Subject: Dresden Station Units 2 and 3  
Quad Cities Station Units 1 and 2  
Zion Station Units 1 and 2  
Additional Response concerning  
Adequacy of Station Electric  
Distribution System Voltages  
NRC Docket No.s 50-237/249,  
50-254/265 and 50-295/304

Enclosure 1

Dresden Station Units 2 & 3  
Quad Cities Station Units 1 & 2

Zion Station Units 1 & 2

DRESDEN UNIT 2  
RAT (TR.#22) CARRYING UNIT 2 SHUTDOWN LOAD  
AND UNIT 3 ESF LOAD THRU INTER.UNIT TIE

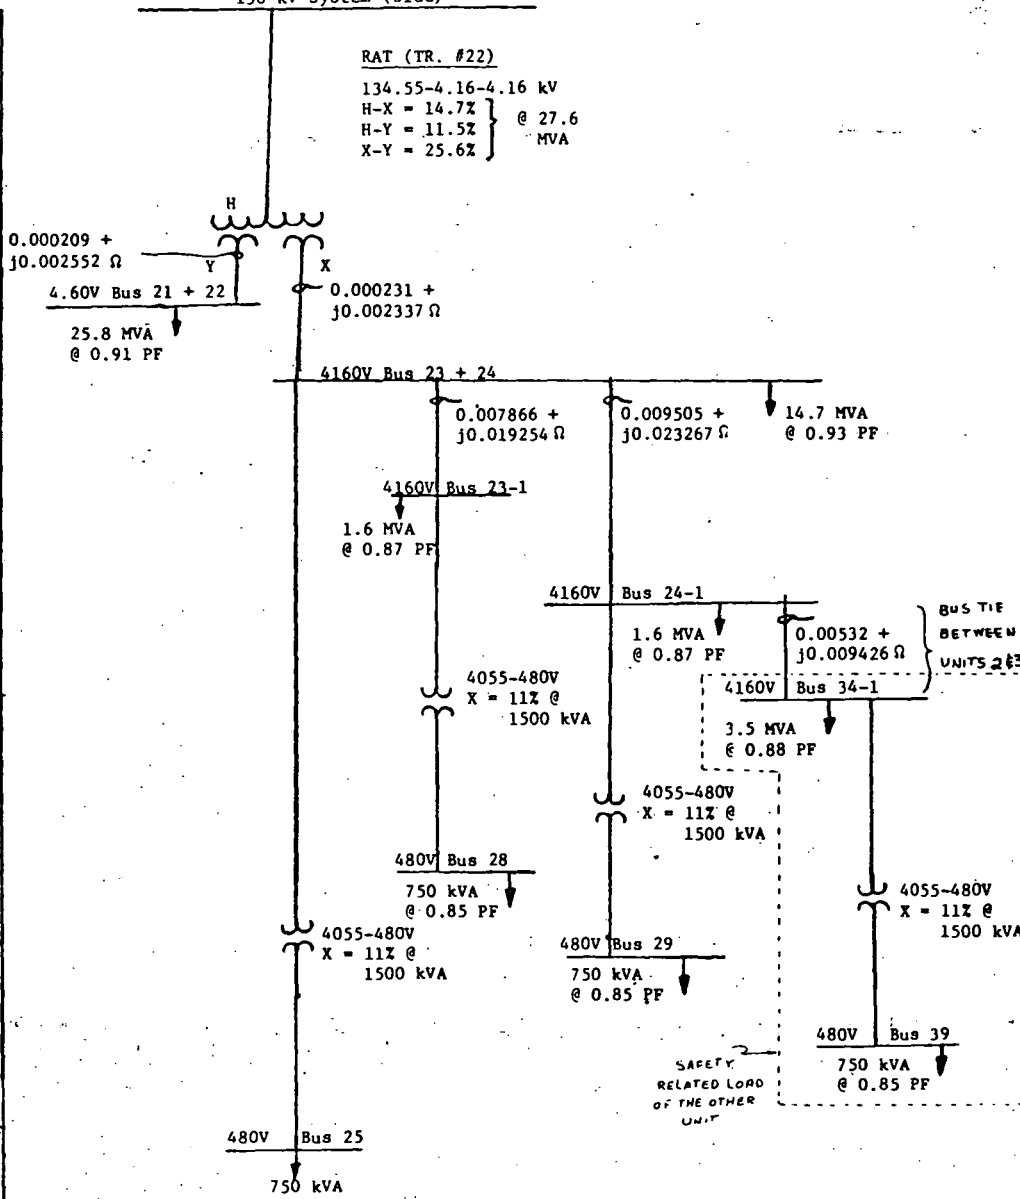
Each SAT is capable of supplying its own unit's auxiliary load and the emergency load of the other unit (see the summary e,f,g). NRC guideline 2 requires the voltage study for the largest load demand including when one unit is in LOCA and the other unit is in safe shutdown. The intertie between buses 24-1 and 34-1 (Dresden)<sup>e</sup>, 14-1 and 24-1 (Quad Cities)<sup>f</sup>, and a similar arrangement for Zion (bus numbers are unreadable in the report)<sup>g</sup> demand this voltage analysis.

Attachment 1 shows the voltages at the buses and at the loads when Tr.#22 (RAT/SAT) is carrying the shutdown load (e.g. unit trip) of Unit 2 as well as the Engineered Safeguard System (ESS) loads (connected to 4160V bus 34-1) of Unit 3 through the intertie between 4160V buses 24-1 and 34-1.

The results indicate that:

1. The running voltage at the 460V motors is less than 90% of motor rated voltage.
2. The motor starting voltage of the 9000HP Rx feed pump is less than 75% of the motor rated load.

ZION AUXILIARY SYSTEM PERFORMANCE  
UNIT TRIP WITH LOCA ON OTHER UNIT  
PROPOSED CORRECTIVE MEASURES USED  
(SHED 2 COND. BOOST PUMPS & 1 CIRC. WATER PUMP)

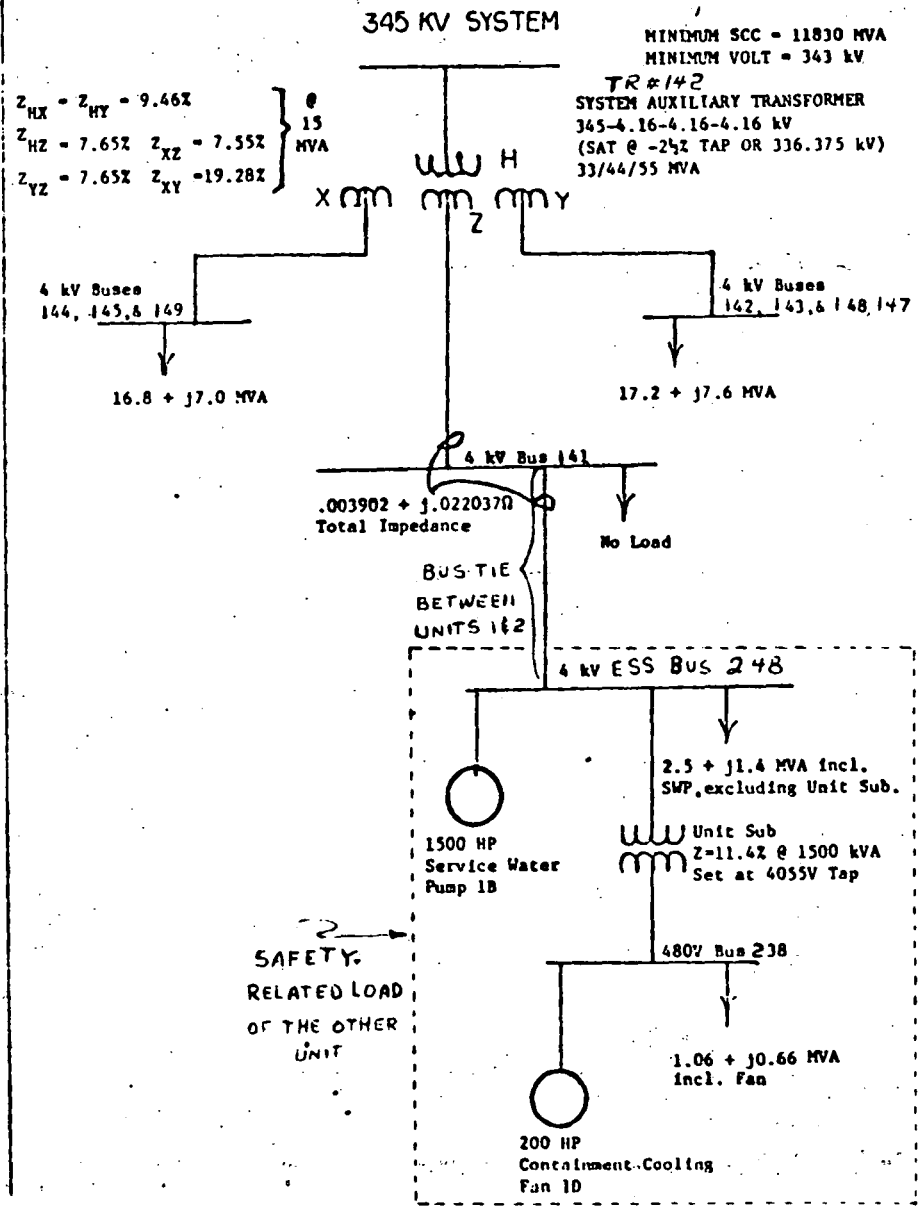
Each SAT is capable of supplying its own unit's auxiliary load and the emergency load of the other unit (see the summary e,f,g). NRC guideline 2 requires the voltage study for the largest load demand including when one unit is in LOCA and the other unit is in safe shutdown. The intertie between buses 24-1 and 34-1 (Dresden)<sup>e</sup>, 14-1 and 24-1 (Quad Cities)<sup>f</sup>, and a similar arrangement for Zion (bus numbers are unreadable in the report)<sup>g</sup> demand this voltage analysis.

Analyses were performed to determine the voltages on an Engineered Safeguard System (ESS) bus of one unit while being supplied from the SAT of the other unit. The case where a SAT carries its normal operating load and an ESS bus of the other unit was analyzed in the November 1, 1979 and June 23, 1980 reports.

Attachment 1 shows the voltages at the buses and at the loads, with the largest load demand on the SAT, and minimum expected voltage on the 345Kv grid system. The SAT (TR#142) is carrying all the shutdown load (e.g. unit trip) of Unit 1 and one Division ESS loads (4KV bus 248) of Unit 2 through the intertie between 4KV buses 141 and 248. The calculations show that voltages on the 4KV buses are satisfactory. The lowest voltage on the 480 volt bus occurs while starting the containment cooling fan. Including the impedance of the cable feeding the motor, the starting voltage at the motor terminals is calculated to be 76.3% of motor rated voltage. The running voltage at the motor terminals is 93% of motor rated voltage.

The calculations of the SAT for Unit 2 (Tr#242) feeding the ESS bus of Unit 1 will result in the same voltages shown on the attachment.
